IN THE DRAWINGS

The attached sheet of drawings includes changes to FIGS. 2, 6, 9, 10, and 13. These sheets, which include FIGS. 2, 6, 9, 10, and 13, replace the original sheets of FIGS. 2, 6, 9, 10, and 13.

Ravi Nair, et al.  
AUS9-2000-0001-US1

FIG. 2

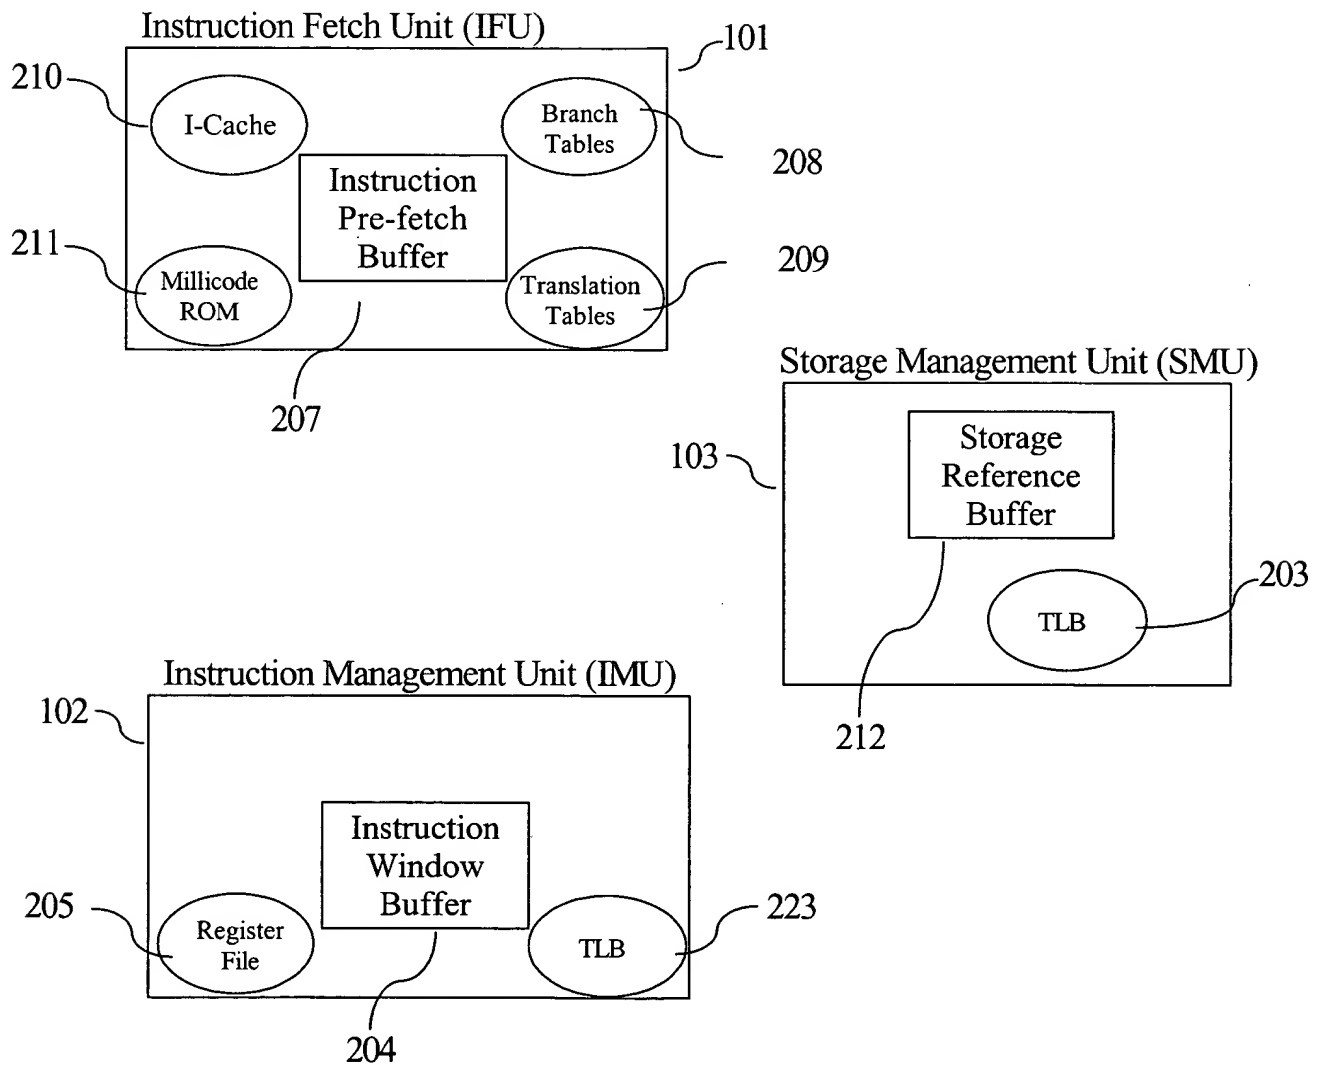
FIG. 2 has been amended to change the TLB 203 in SMU 103 to TLB 223.

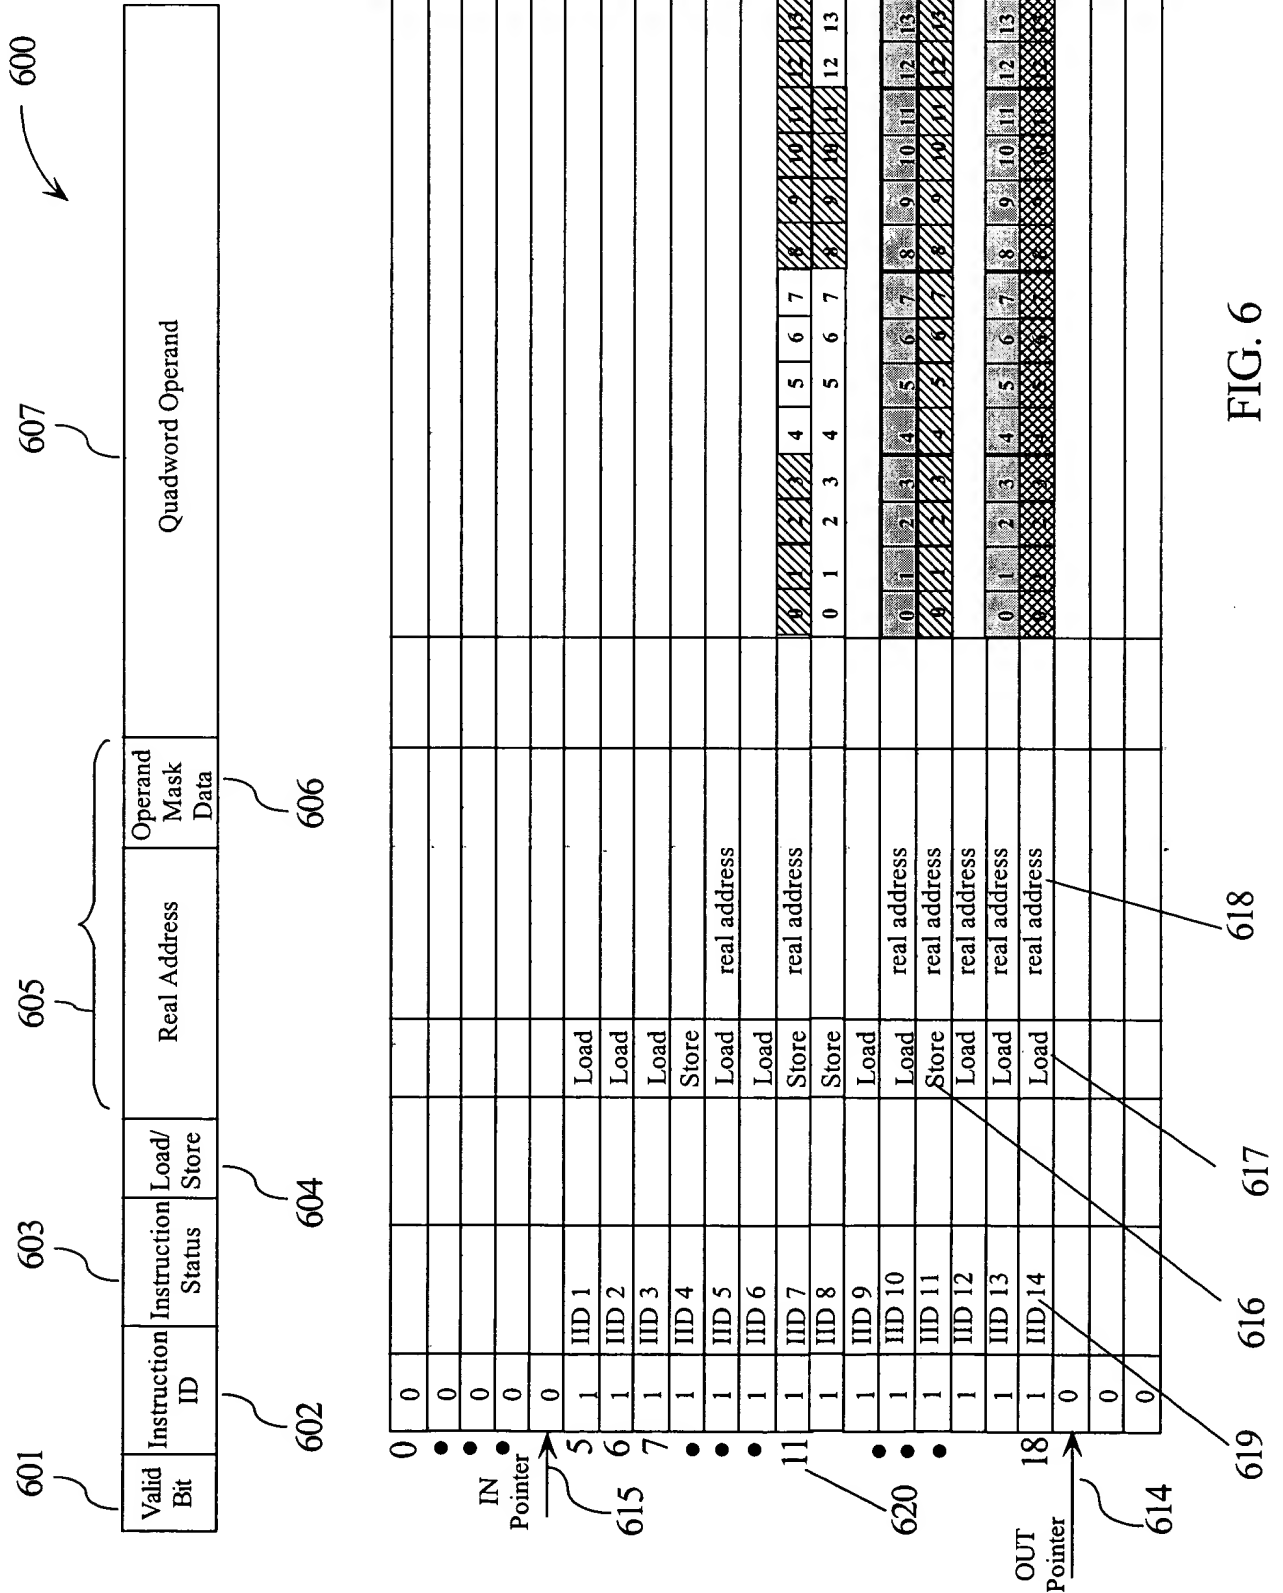
FIG. 6 has been amended to change Operand Mask 606 to Operand Mask Data 606 to more clearly distinguish between the data that defines a portion of the Quadword Operand and that portion of the Quadword that is under the Operand Mask itself.

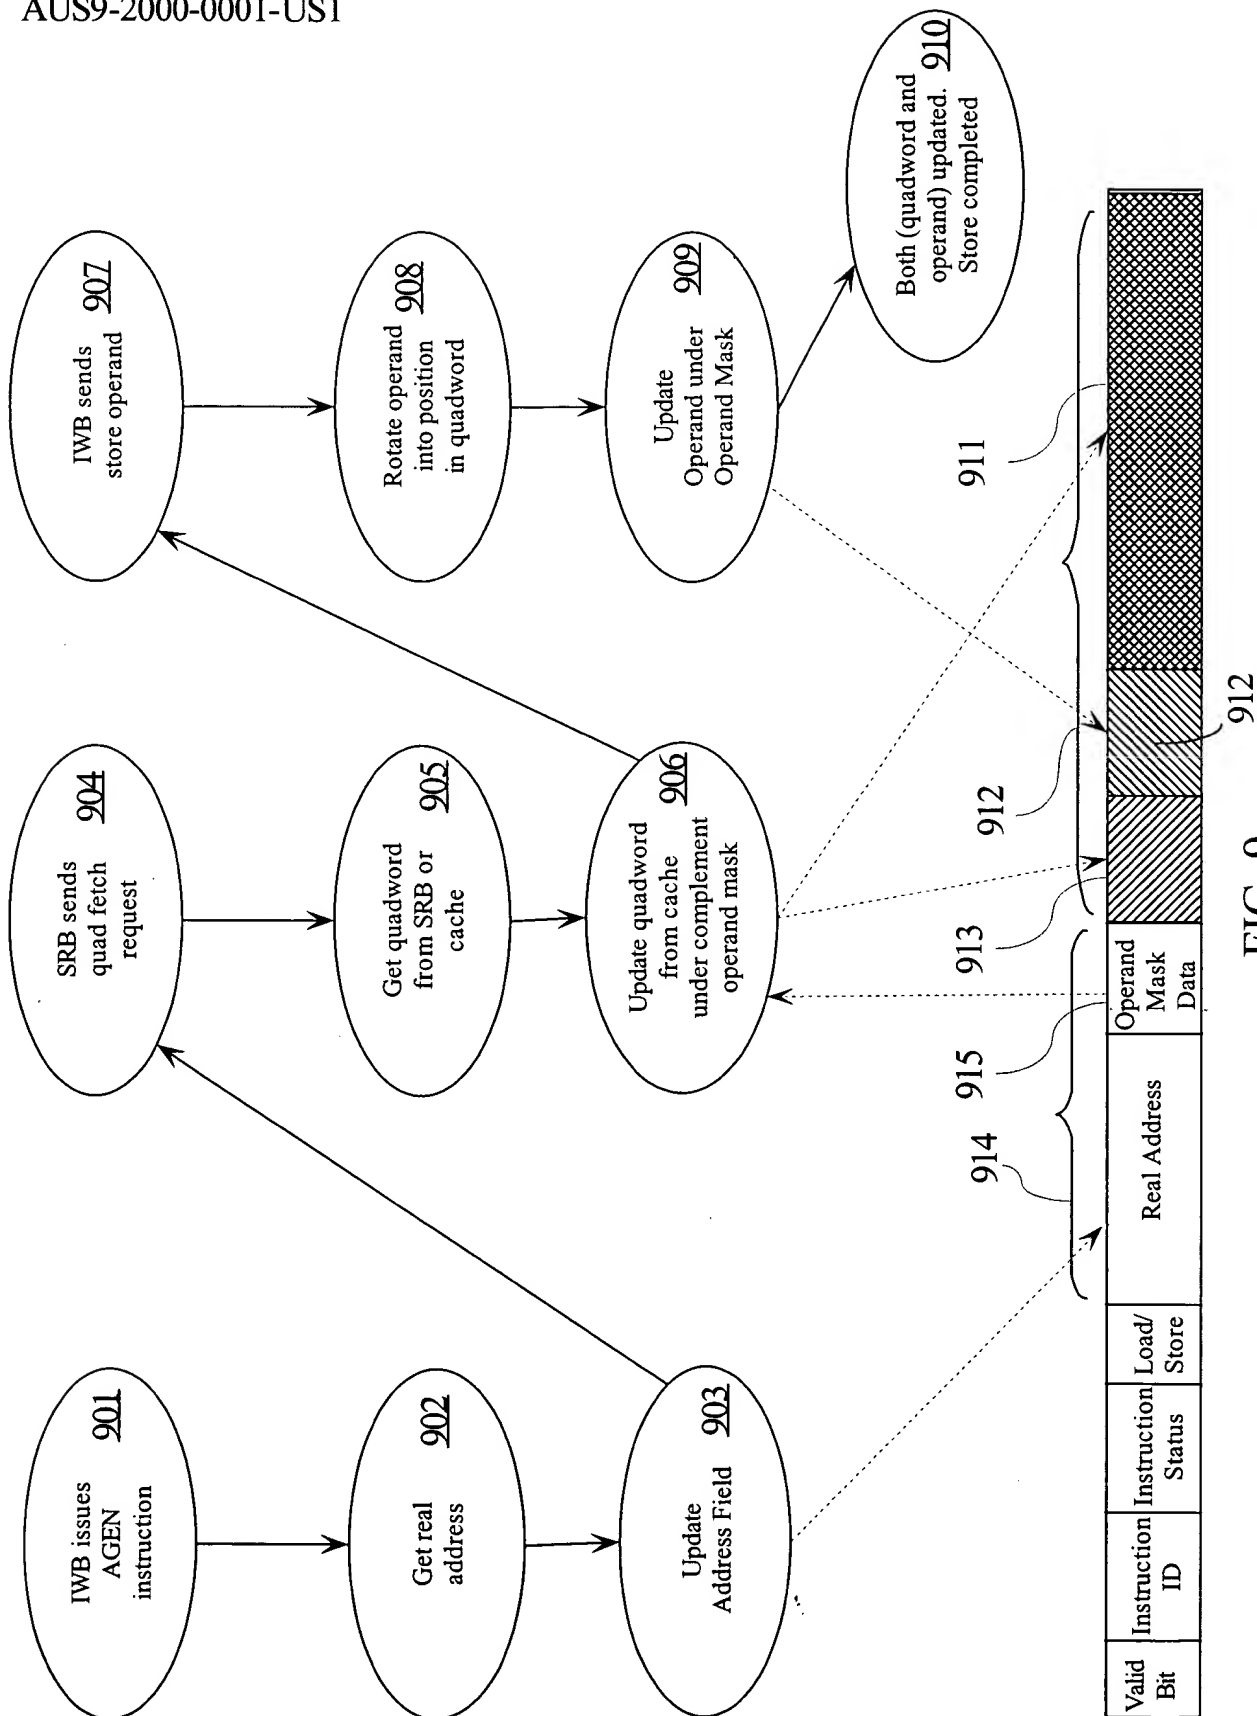
FIG. 9 has been amended to add a couple of brackets to more clearly indicate that 912 is the Quadword and 911 is a portion of the Quadword under a complement Operand Mask. FIG. 9 has been further amended to add a couple of brackets to more clearly indicate what is Real Address 914 and what is Quadword 912. A new designator 916 was added that corresponds to the section of Quadword 912 pointed to by step 909 as "Operand Mask." Likewise, to avoid confusion section 915 was renamed "Operand Mask Data" from "Operand Mask." The Operand Mask Data 915 defines which portion of Quadword 912 is the "Operand" under the "Operand Mask 916" updated in step 909.

FIG. 10

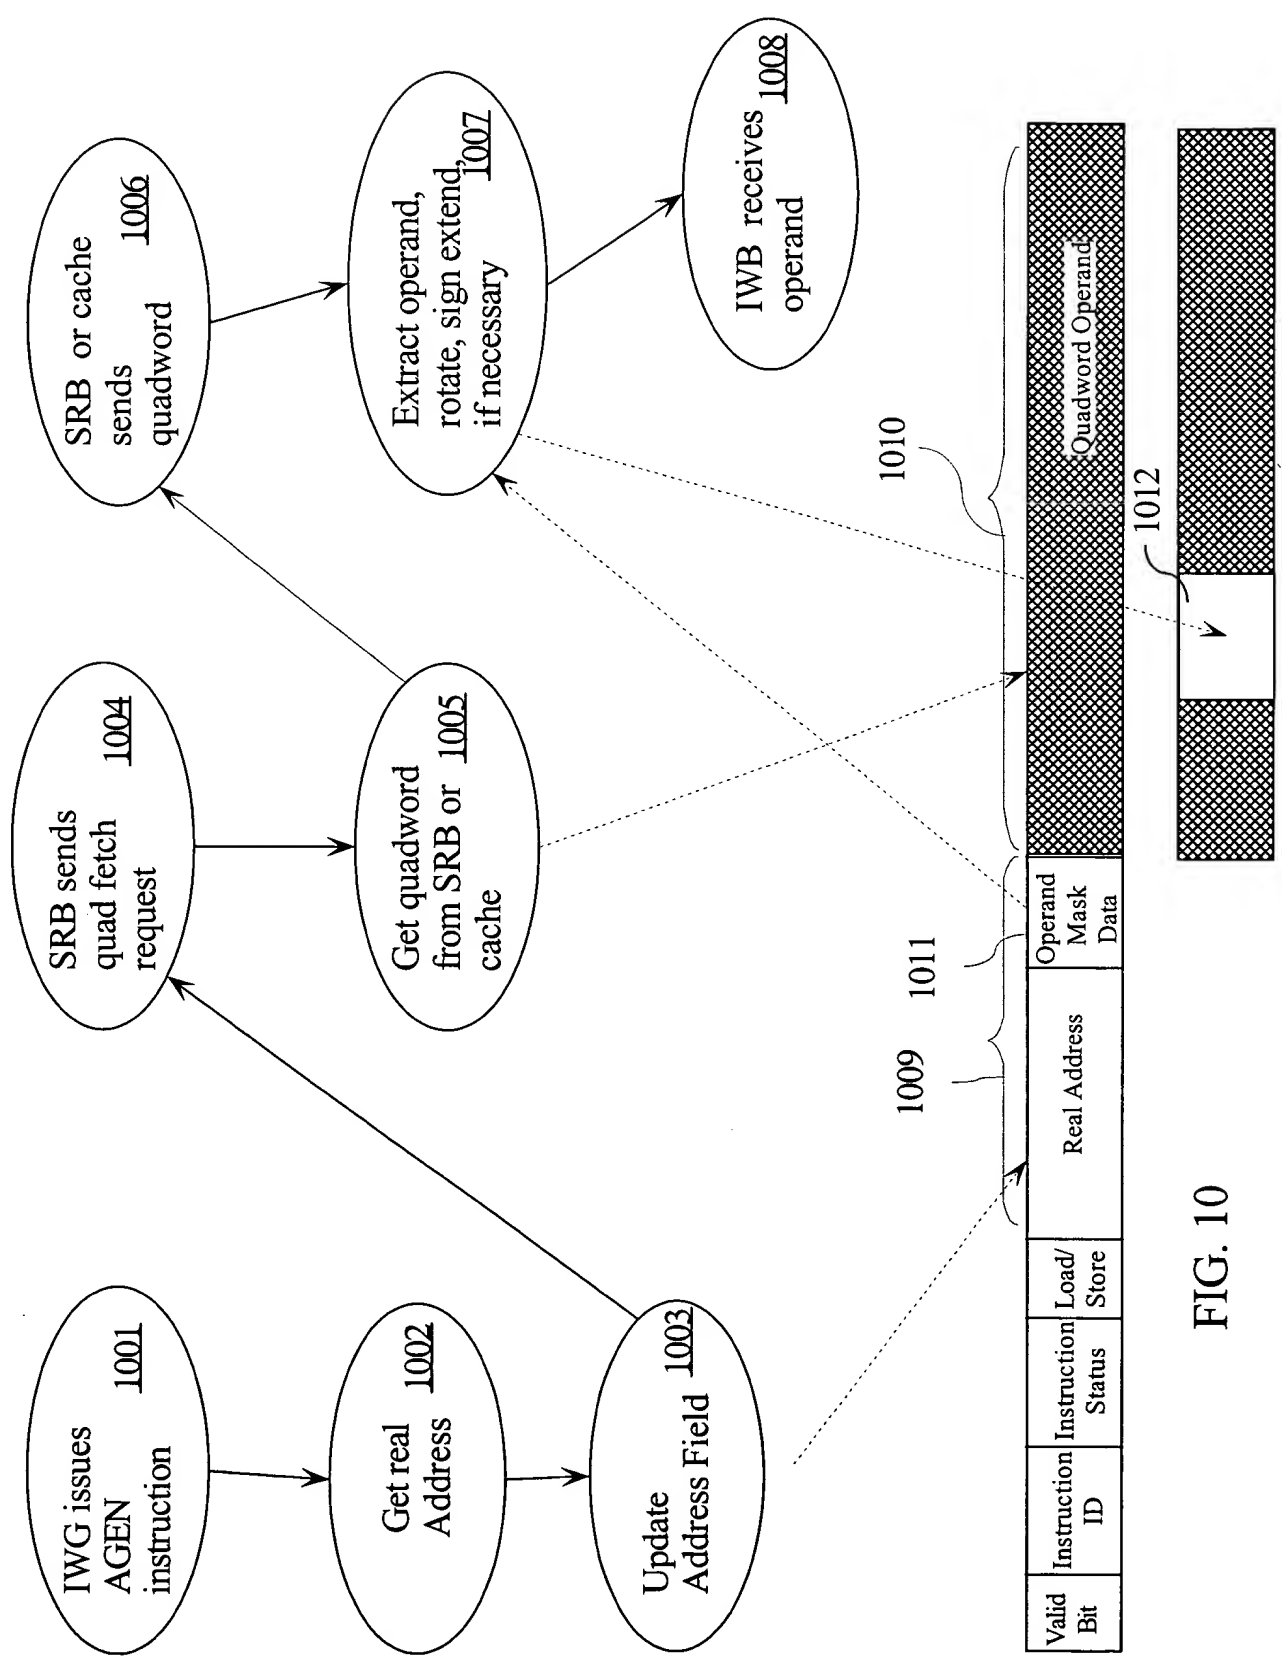
FIG. 10 has been amended to add a couple of brackets to more clearly indicate what is Real Address 1009 and what is Quadword 1010. A new designator 1012 was added that corresponds to the section of Quadword 1010 pointed to by step 1008. Likewise, to avoid confusion section 1011 was renamed "Operand Mask Data" from "Operand Mask." The Operand Mask Data 915 defines which portion of Quadword 1010 is the "Operand" under the "Operand Mask 1012" extracted in step 1008.
